| <b>PCN Number</b> | PCN-20250819                                      |
| <b>Title</b>      | TEF0008-02 to TEF0008-03 Hardware Revision Change |

This change affects all Trenz Electronic TEF0008 boards: TEF0008-02-D.

## #12 Added UKCA-, RoHS- and ESD-logo.

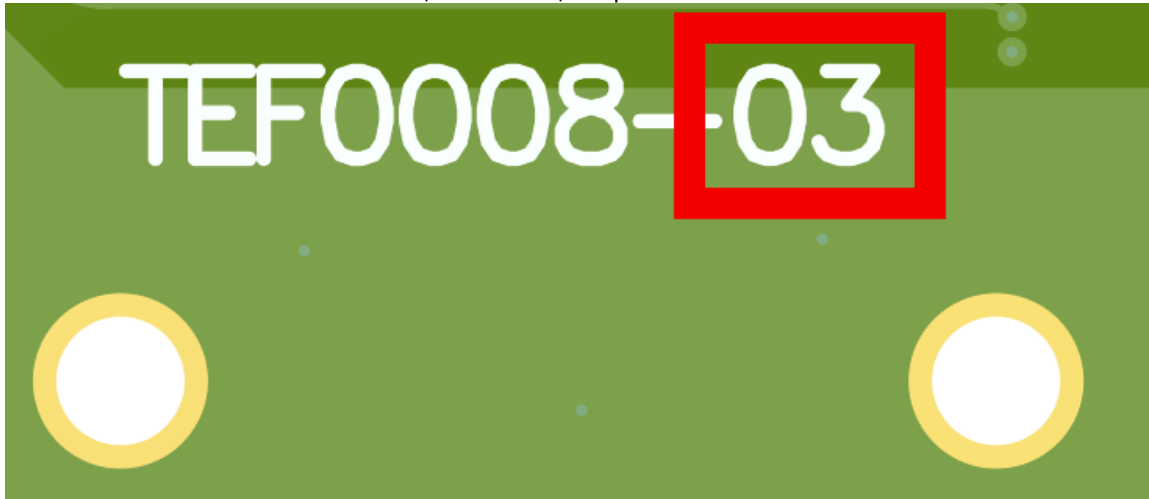
**Type:** PCB Change

**Reason:** Improve product classification.

**Impact:** None.
